SITE DEVELOPMENT PLAN, AMENDMENT NO. 1 THE BRINKERHOFF & BAR HUMMINGBIRD

LOT 1A-3A, BLOCK 2, PROMENADE AT CASTLE ROCK FILING NO. 1, AMENDMENT NO. 13
LOCATED IN THE SW QUARTER OF SECTION 22, TOWNSHIP 7 SOUTH, RANGE 67 WEST,
OF THE 6TH PRINCIPAL MERIDIAN, TOWN OF CASTLE ROCK, COUNTY OF DOUGLAS, STATE OF COLORADO

CHANGES FROM APPROVED SDP AMENDMENT #1

REVISION SDP AMENDMENT

PLANTING NOTES/ CALCULATIONS/ DETAILS

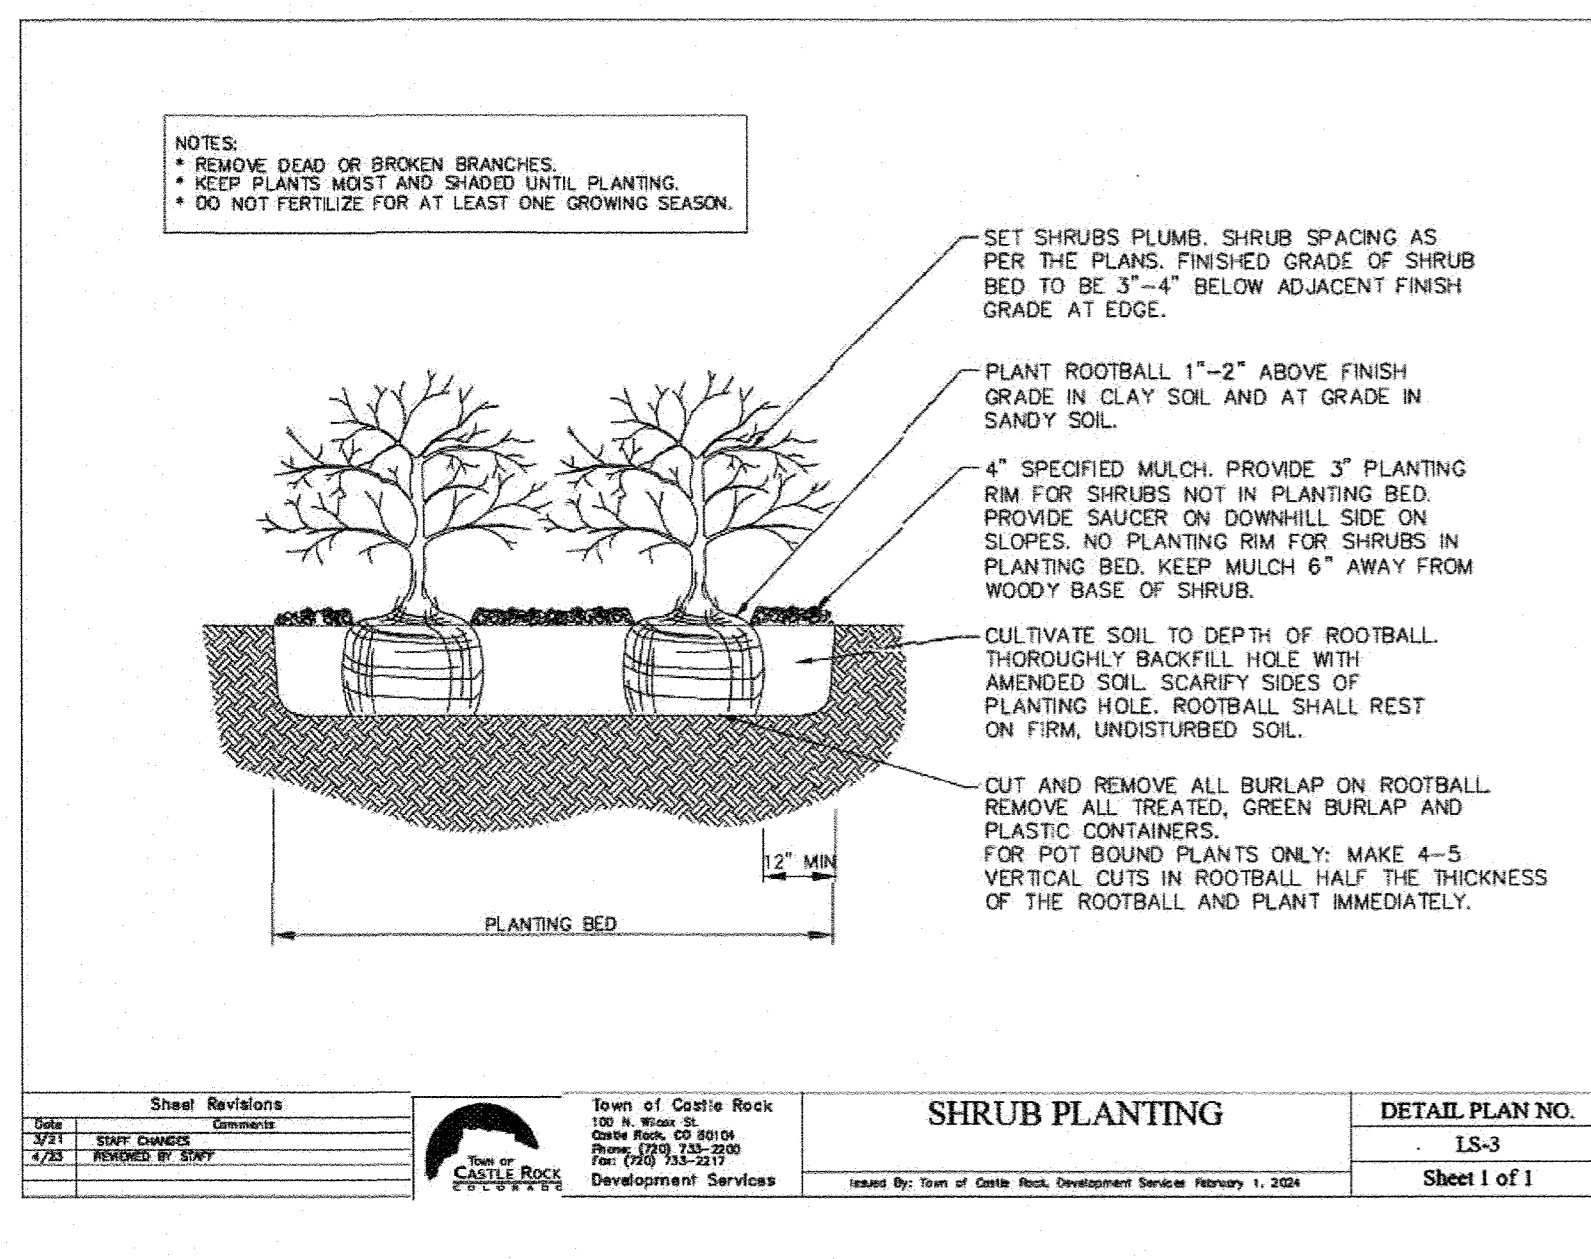
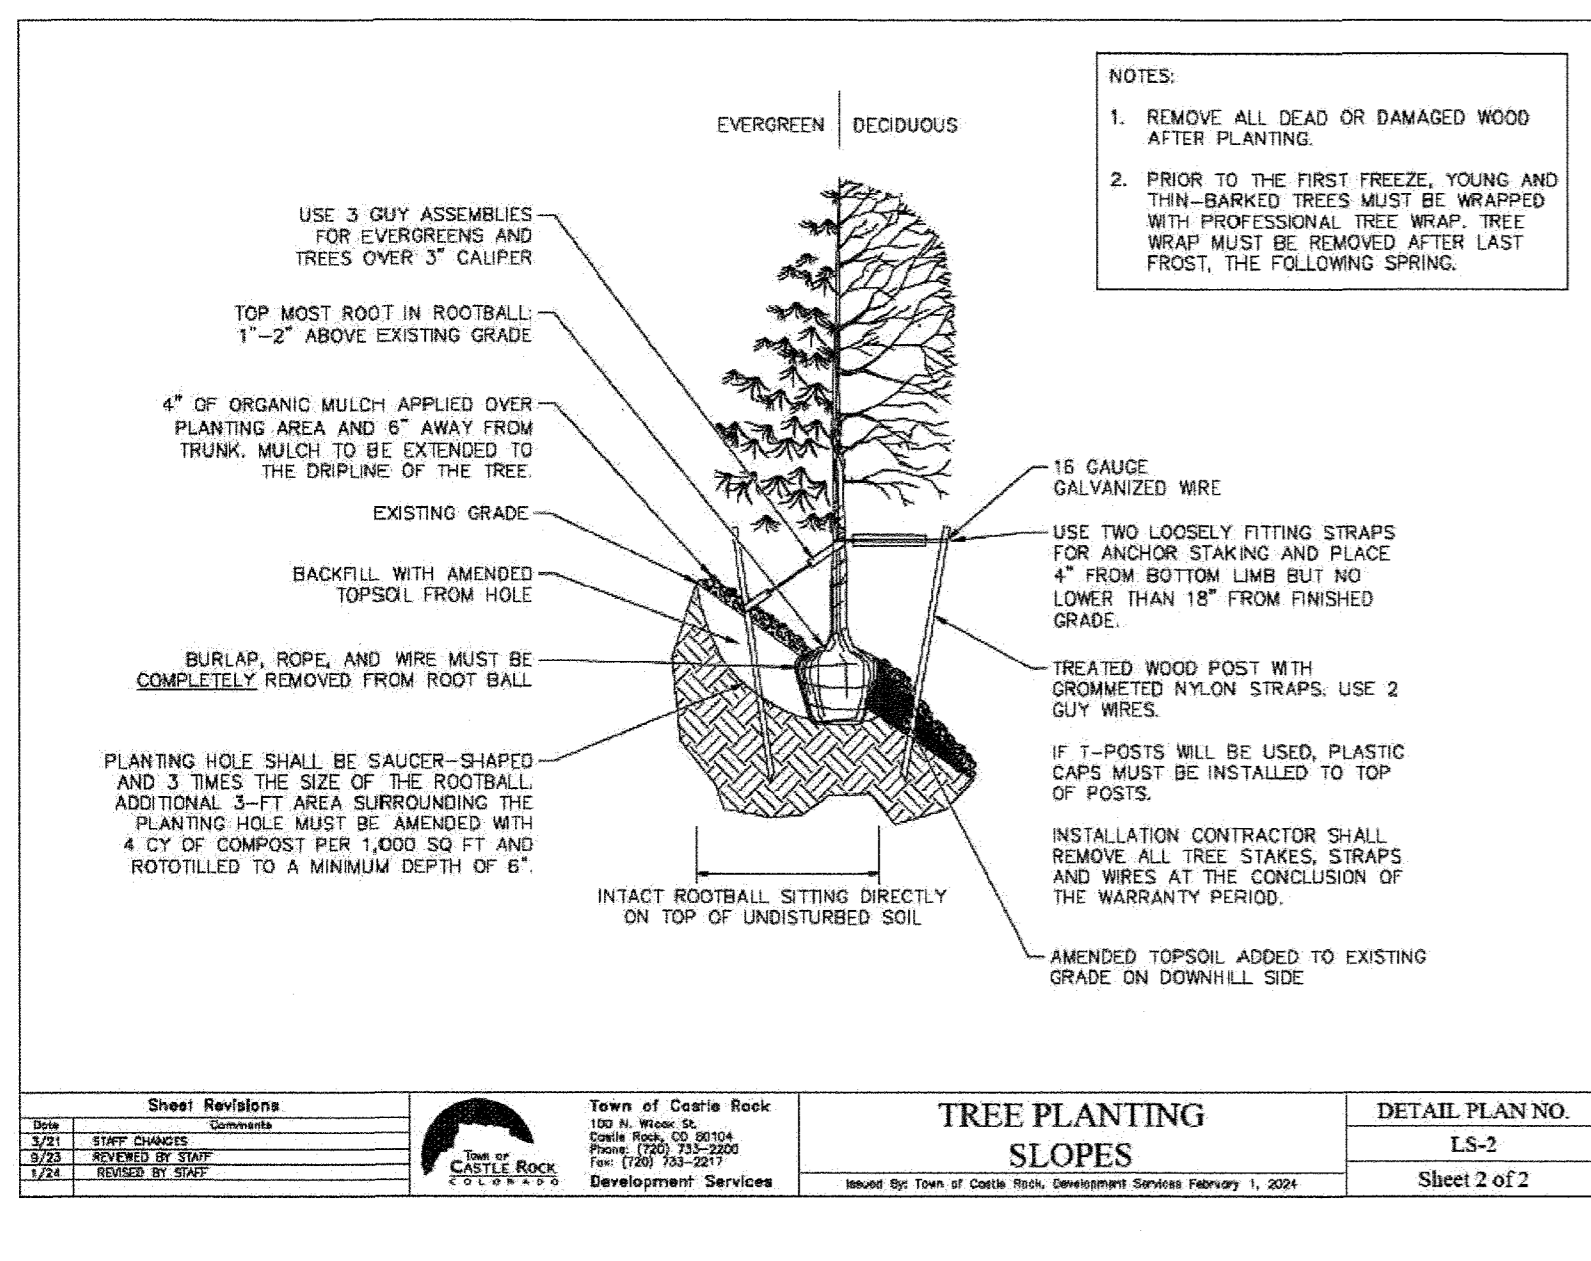
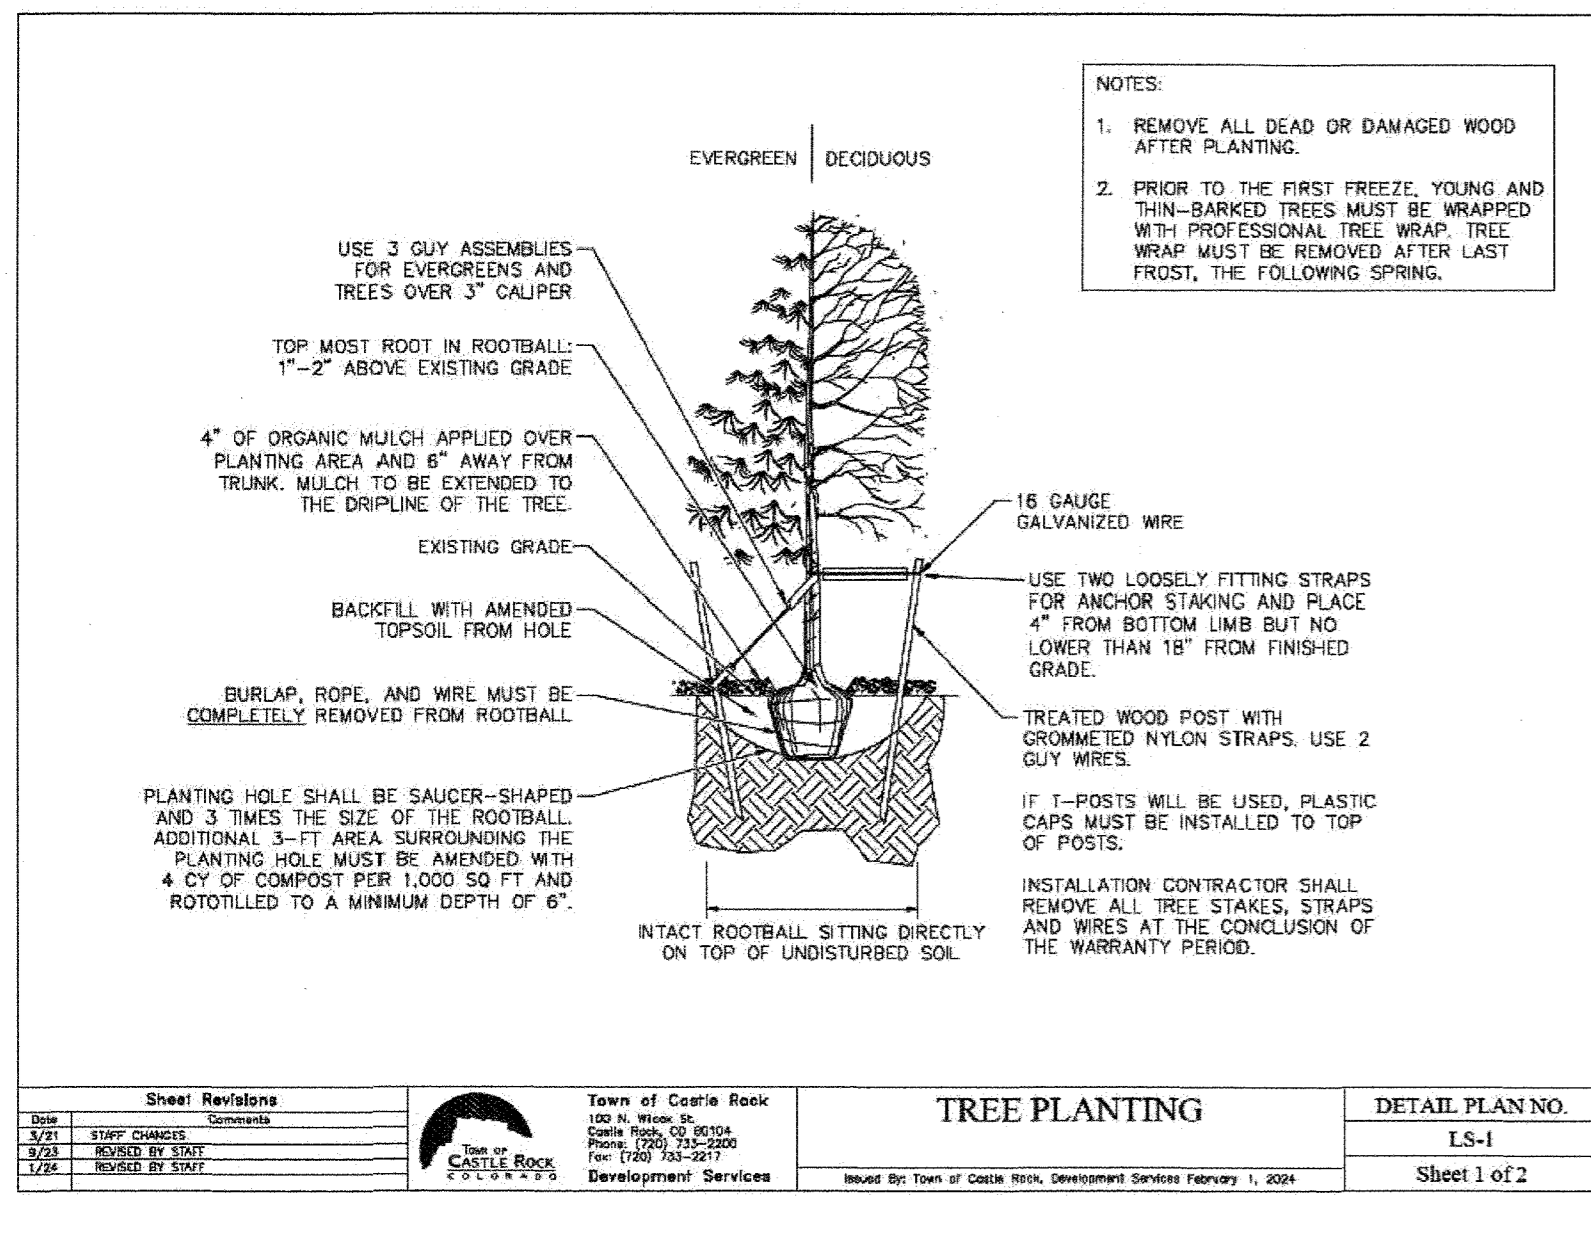
- TABLES WERE UPDATED TO MATCH THE TOWN'S CURRENT AND APPROVED LANDSCAPE TABLES.
- OVERALL SHRUB AND GRASS COUNTS WERE REDUCED AND REPLACED BY NATIVE SEED AREAS.
- TREE COUNTS INCREASED FROM 80 TO 92 ON SITE.

THE BRINKERHOFF & BAR HUMMINGBIRD
 CASTLE ROCK PROMENADE, BLOCK 2
 CASTLE ROCK, COLORADO 80108
SITE LIGHTING PLAN

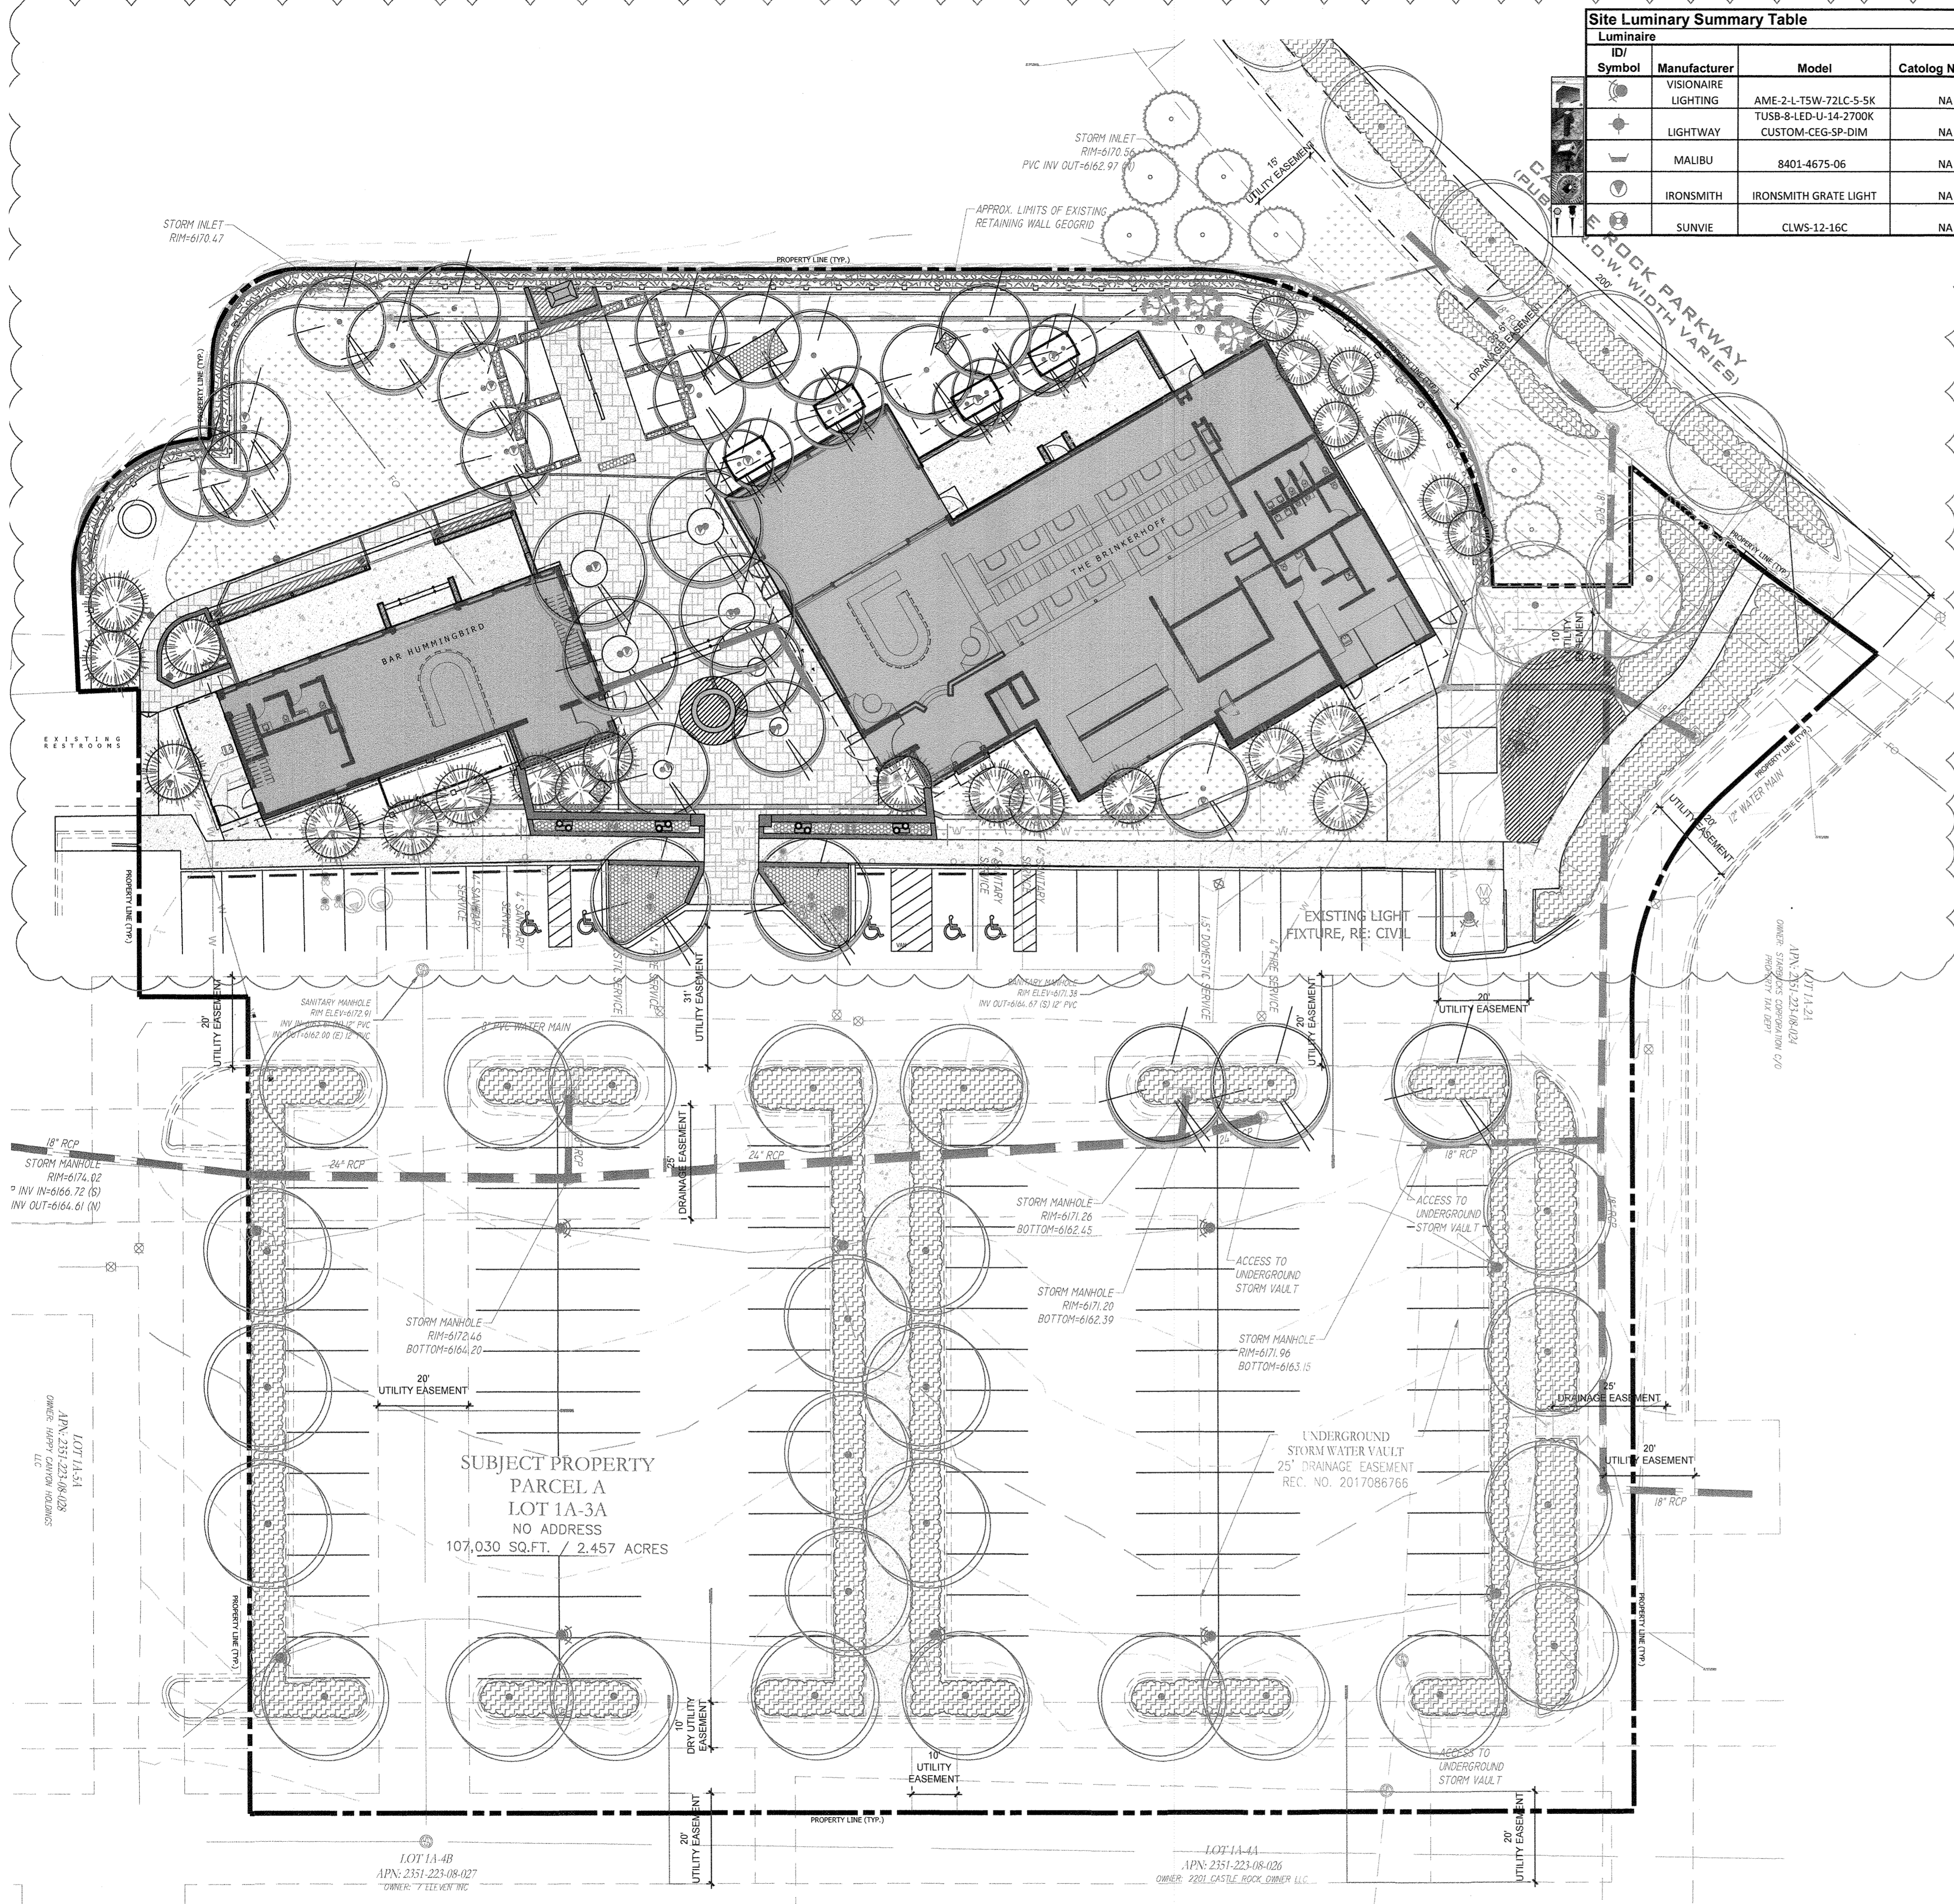
LIGHTING CHANGES:

- OVERALL LANDSCAPE LIGHTING WAS REDUCED FOR ENERGY SAVINGS AND TO PROVIDE MORE COMFORTABLE AMBIANCE FOR PATRONS.
- TWO TYPES OF LIGHTING FIXTURES WERE REMOVED, THE STEP / CAP LIGHT FIXTURE AND OUTDOOR CHANDELIER FIXTURE. A NEW FLOODLIGHT WAS ADDED TO THE ENTRANCE WALLS TO PROVIDE MORE VISIBILITY TO THE ENTRANCE.
- AN EXISTING LIGHT POLE IN THE PARKING LOT WAS SHIFTED FURTHER FROM THE CURB TO AVOID ANY VEHICLE COLLISIONS AND IMPROVE LINE OF SIGHT ON THE NORTH EAST CORNER OF THE BRINKERHOFF.
